**REQUEST**

**(ST2515) GRI Jenison LLC**, 1422 Rosewood St., is requesting a minor change to their site plan to add 34 parking spaces (each 9 by 20 feet) to the southwest area of the site, current uses permitted under Sec. 17.2 (S), on a parcel of land described as P.P. # 70-14-23-100-099 located at 1422 Rosewood St., in an Industrial (I) district, Georgetown Township, Ottawa County, MI.

## **SITE PLAN APPROVAL**

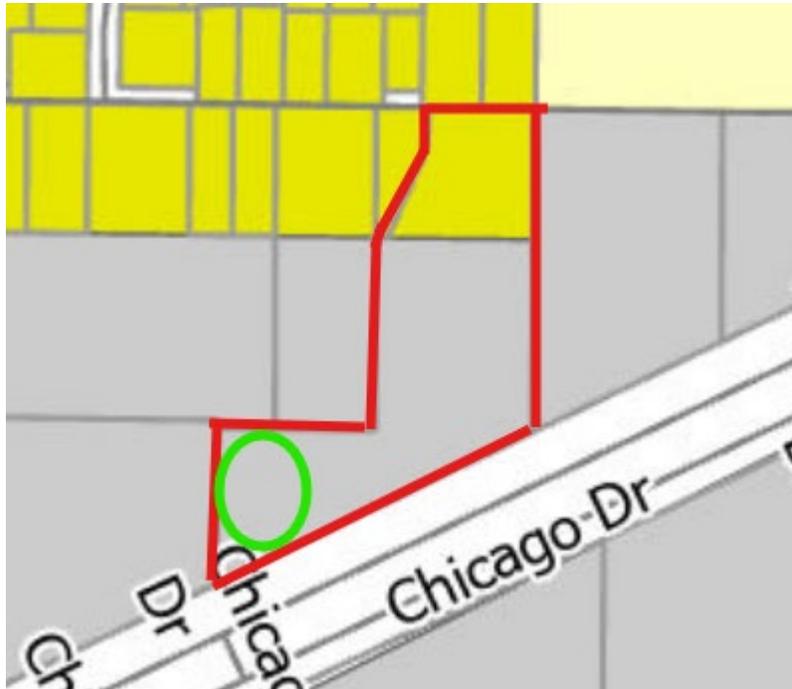
\*Green circle indicates location of proposed parking expansion.
